Date : 9/9/2019 5:40:45 PM
From : "William Delvac"
To : "Lambert M. Giessinger (lambert.giessinger@lacity.org)" , "jaso"
Cc : "dtwerdun@lefrak.com"
Subject : FW: Hollywood & Wilcox
Attachment : 86213 HW-WX SITE_PLAN_REVIEW_2019.0826.pdf;

PROPOSED PROJECT WITH ATTIE BUILDING AFTER RESTORATION

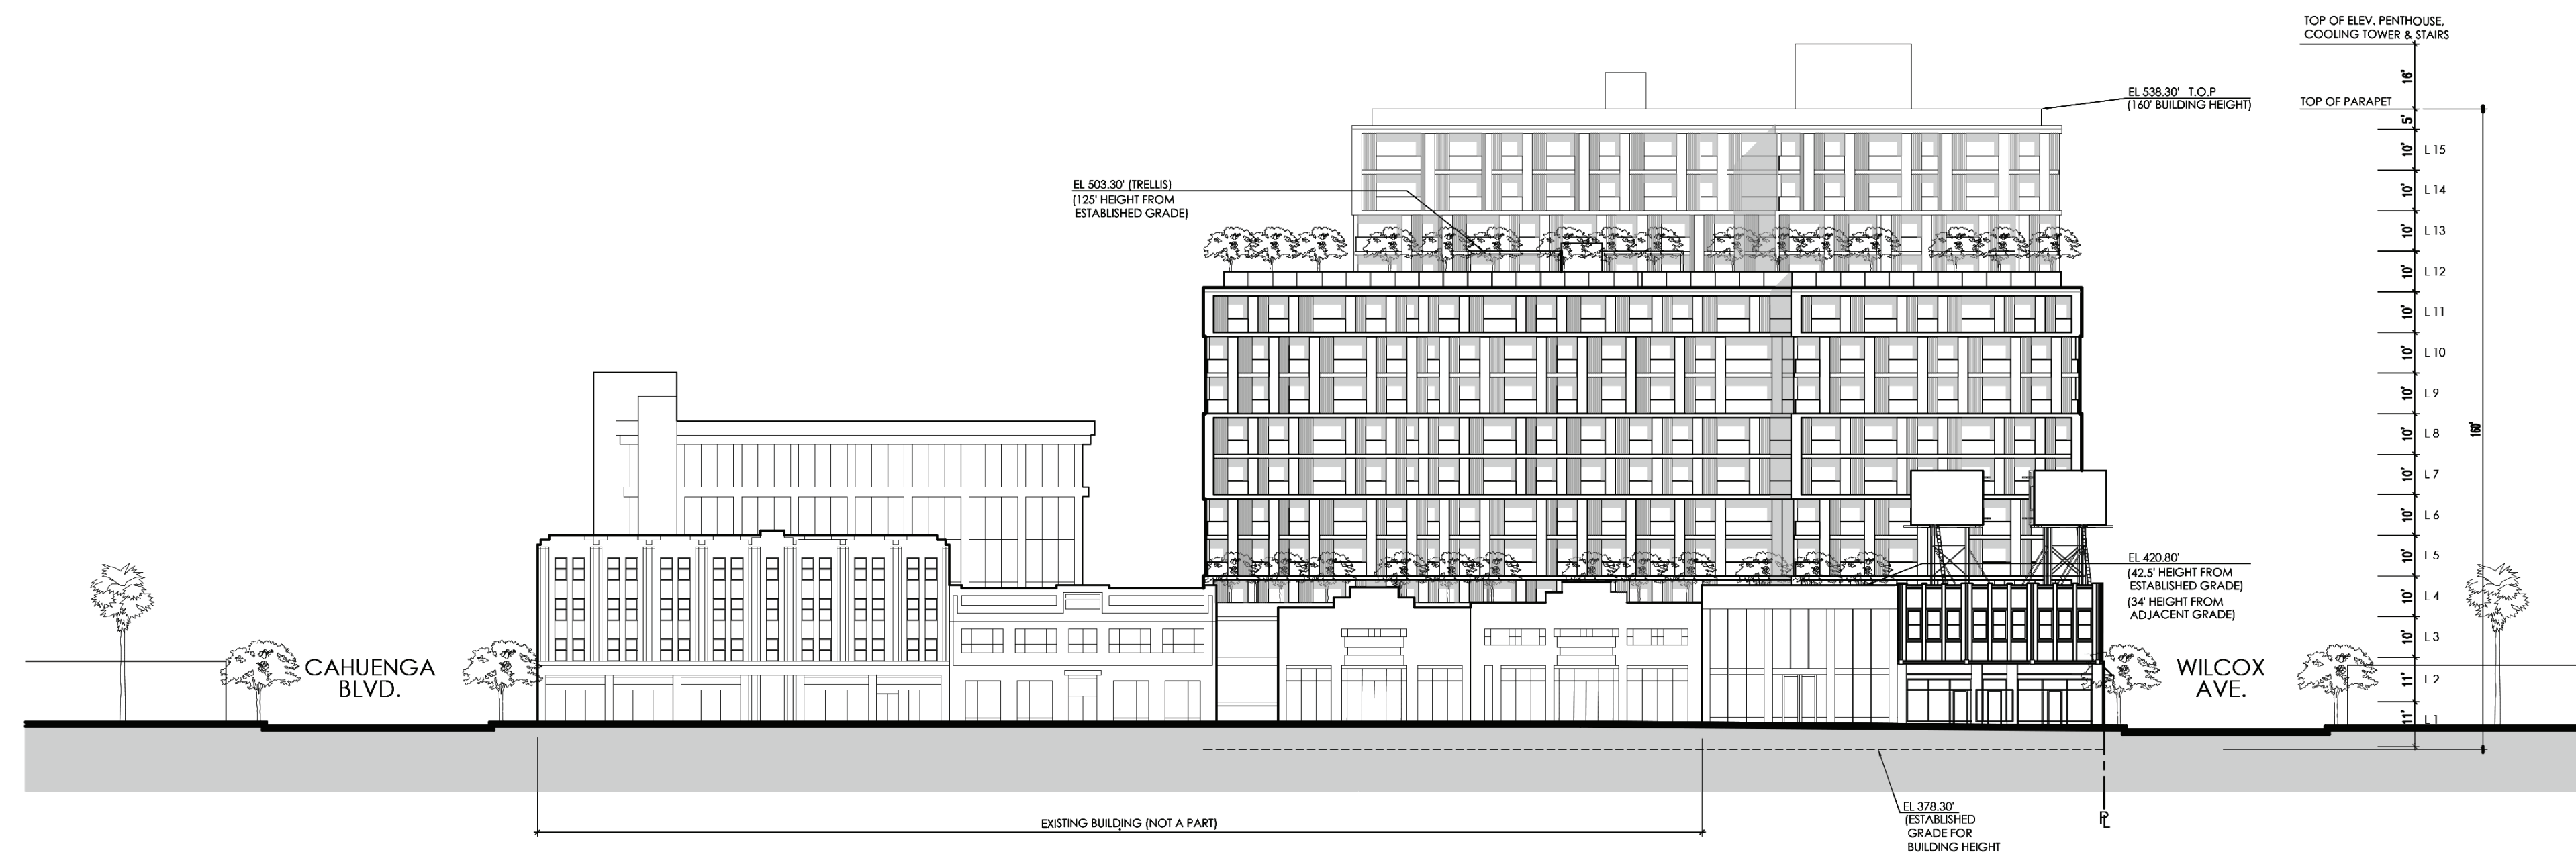
1. We agreed that the new storefront of the Attie Building would not cover the historic spandrel panels on the second floor. The attached drawings
2. We agreed to see if we could "line up" the thicker pilaster on the second floor with the column near the edge of the mural on the first floor (along the Wilcox frontage). The attached show that this was successfully resolved.

Note these versions of the drawings still show the original design (white with some yellow panels) of the residential building in the back.
